# PIC16F631/677/685/687/689/690

## PIC16F631/677/685/687/689/690 Family Silicon Errata and Data Sheet Clarification

The PIC16F631/677/685/687/689/690 family devices that you have received conform functionally to the current Device Data Sheet (DS41262E), except for the anomalies described in this document.

FIGURE 8-2: COMPARATOR C1 SIMPLIFIED BLOCK DIAGRAM

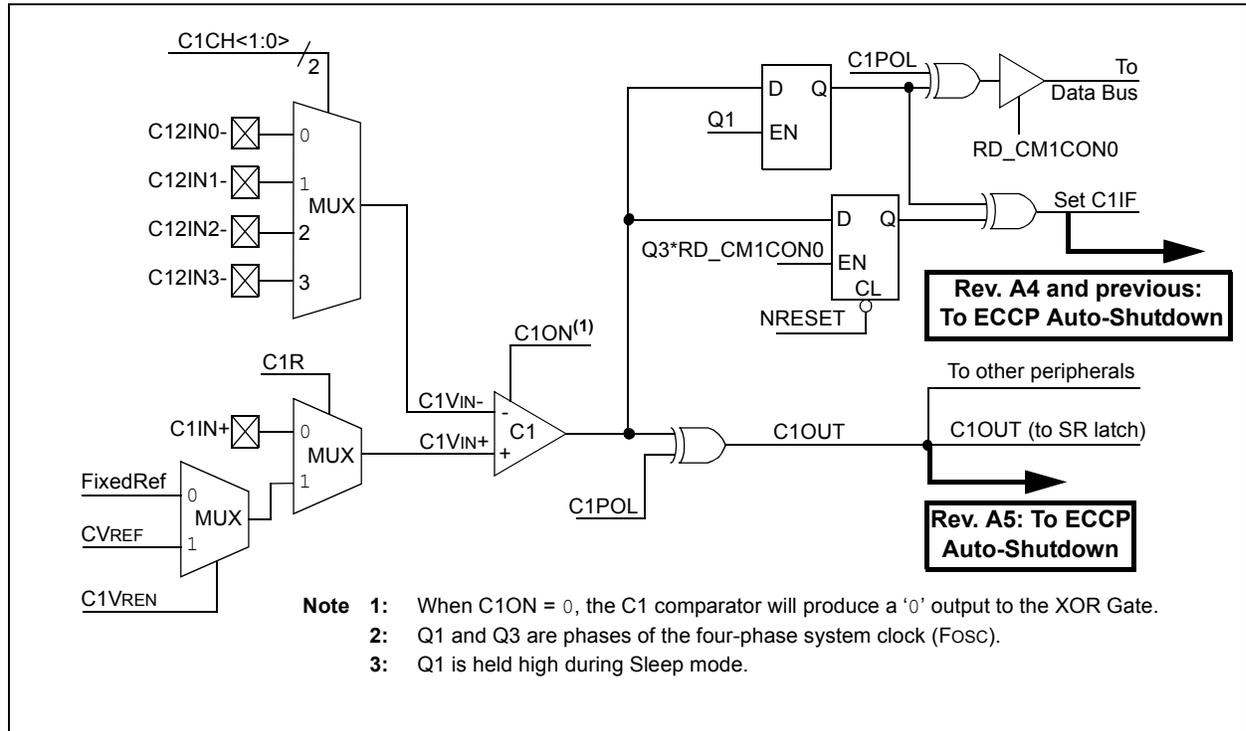
The PIC16F631/677/685/687/689/690 Rev. A4 silicon for the ECCP auto-shutdown is connected to the C1IF and C2IF flags. See Figures 8-2 and 8-3 on the following page.

The auto-shutdown connection (Rev. A4 and previous) to C1IF and C2IF causes the auto-shutdown to incorrectly operate synchronously. Additionally, reads of CMxCON0 will incorrectly clear an auto-shutdown event.

- 1) Poll the CxOUT bit until it is low.
- 2) Read CMxCON0 to precondition CxIF.
- 3) If CMxCON0 is read while CxOUT is changing, repeat steps 1 and 2.

The Silicon Rev. A5 (now shipping) and later revision devices have moved the auto-shutdown connection from CxIF to CxOUT. This will eliminate the synchronous shutdown and simplify the use of the comparator for a shutdown event. Figure 1 shows the function of auto-shutdown before and after the device revision.
